Research Note 85-1

SINGARS-V MATURITY OPERATIONAL TEST:
HUMAN FACTORS EVALUATION (SYNOPSIS)

January 1985

Figure 1. SINGARS-V Advanced Development Model. Front Panel.

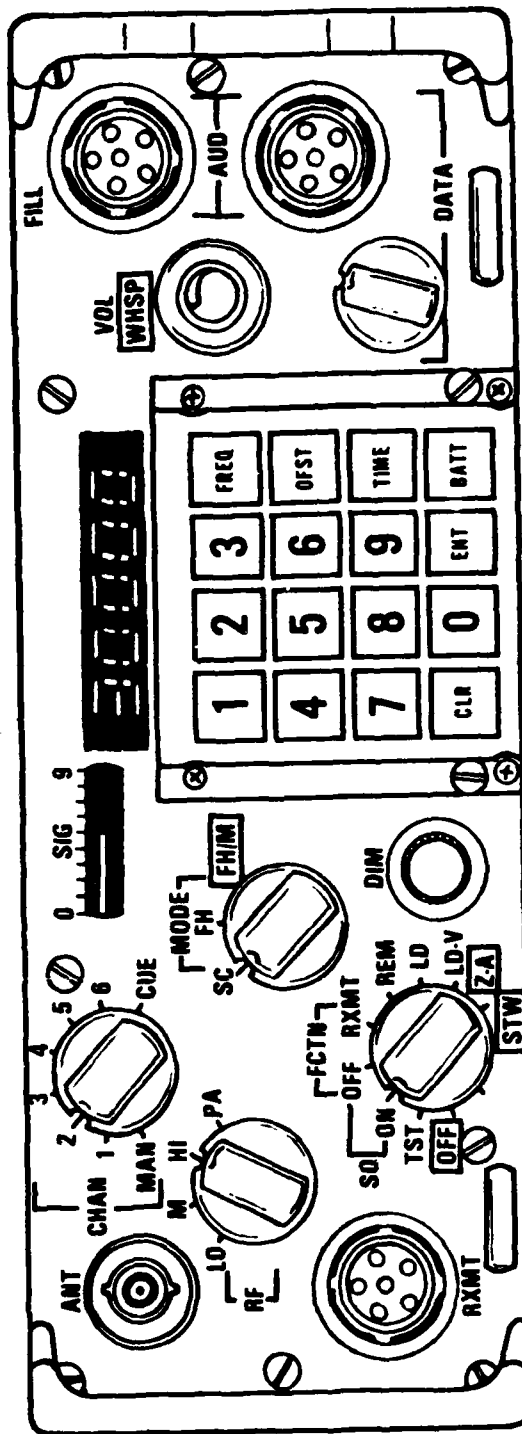
30. The LED display is recessed into the RT front panel so that visual angles greater than about 20 degrees above or below center cut off part of the display. Placement of the RT lower than the operator's eyes seems to be the greater problem. The cut-off of the display, especially from above, resulted in almost a two-hour delay in communication in one field incident. The display should be changed so that it can be accurately read from viewing angles up to 45 degrees.

31. The seven-bar LED display cannot configure a complete alpha-numeric character set. Hence, messages must conform to this limitation, which causes cryptic and difficult-to-understand messages and prompts. Consideration should be given to alternative displays (e.g., nine-bar, or 7 x 9 dot matrix). The display limitation contributes to the "user unfriendliness" of the RT and its software. A means should be created to provide meaningful prompts in a visual form to the operator.

35. The control panel is so crowded that individual controls were not discernable in a night operation using passive night vision goggles. The configuration of controls on the control panel should be reviewed for visibility and improved where possible.

40. The front panel is cluttered by having too much designed into insufficient space. This leaves little space for appropriate labeling. This problem could be alleviated to some extent by improving the labeling and perhaps eliminating unessential labels such as FCTN, CHAN, MODE, and RF.

46. SC controls are intermixed with FH controls. Operation of the RT as a SC radio is complicated by the confusion of controls and their functions. FH and SC controls should be grouped apart to facilitate operator training and use of the RT as a SC radio.
